TP193825 BACKSPACE MAGNET ASSEMBLY

APPARATUS AFFECTED: 28A, 28B, 28D, 28E, 28F, 28G, 28G-1, 28H, 28J, 28J-1, 28K, 28LA Perforator-Transmitter-Bases.

OBJECT: To provide more reliable operation and simplify adjusting procedure.

REASON FOR REISSUE: To revise information under "CHANGE" which was incorrectly specified. TP119648 retainer is changed to read TP119649 retainer.

FIGURE 1. MANUAL AND POWER DRIVE BACKSPACE MECHANISM
FOR CHADLESS OR FULLY PERFORATED
TAPE (LATEST DESIGN)

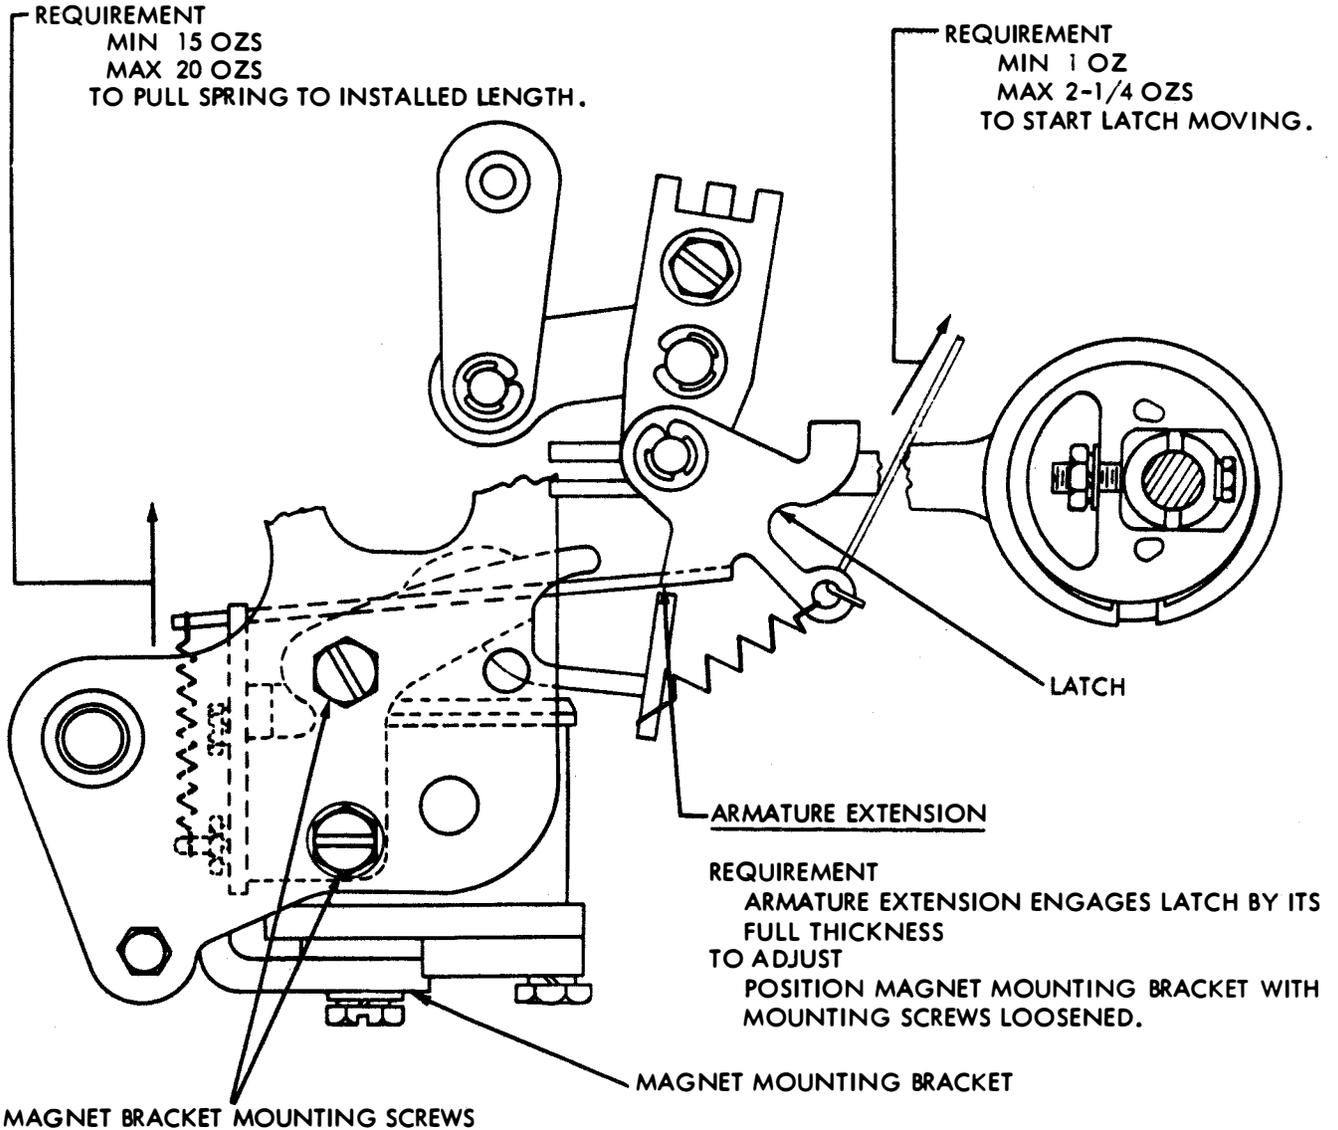
CHANGE: 1. The TP159966 backspace magnet assembly used in the backspace mechanism is replaced by the TP193825 backspace magnet assembly.

2. Requirement is added to Section 573-119-700, Section 573-118-700 and Section 573-117-700, after the last adjustment for the backspace mechanism.

See FIGURE 1.

ARMATURE SPRING

REQUIREMENT
MIN 15 OZS
MAX 20 OZS
TO PULL SPRING TO INSTALLED LENGTH.

LATCH EXTENSION SPRING

REQUIREMENT
MIN 1 OZ
MAX 2-1/4 OZS
TO START LATCH MOVING.

REQUIREMENT
ARMATURE EXTENSION ENGAGES LATCH BY ITS
FULL THICKNESS
TO ADJUST
POSITION MAGNET MOUNTING BRACKET WITH
MOUNTING SCREWS LOOSENED.

FIGURE 1. MANUAL AND POWER DRIVE BACKSPACE MECHANISM
FOR CHADLESS OR FULLY PERFORATED
TAPE (LATEST DESIGN)

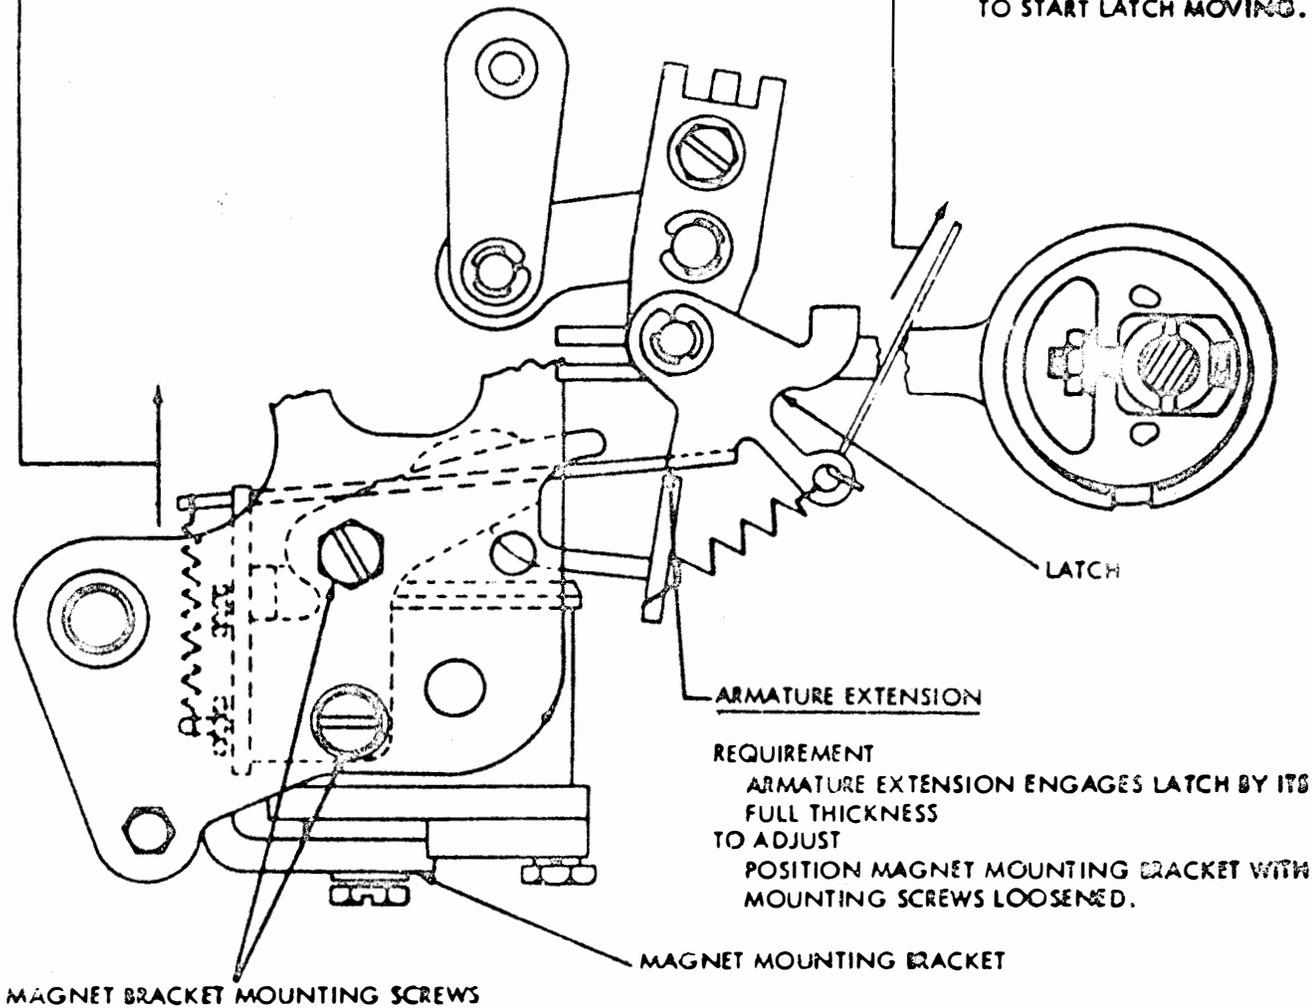
CHANGE: The latching surface of the TP193824 nonrepeat latch lever will be formed toward the hub at a 12-degree angle, 0.044 inch from the top of the latch.

Figure 1 is added to Sections 573-119-700, 573-118-700 and 573-117-700 after the last adjustment for the backspace mechanism.

REQUIREMENT

MIN 15 OZS
MAX 20 OZS
TO PULL SPRING TO INSTALLED LENGTH.

LATCH EXTENSION SPRING

REQUIREMENT

MIN 1 OZ
MAX 2-1/4 OZS
TO START LATCH MOVING.

REQUIREMENT

ARMATURE EXTENSION ENGAGES LATCH BY ITS
FULL THICKNESS
TO ADJUST
POSITION MAGNET MOUNTING BRACKET WITH
MOUNTING SCREWS LOOSENED.
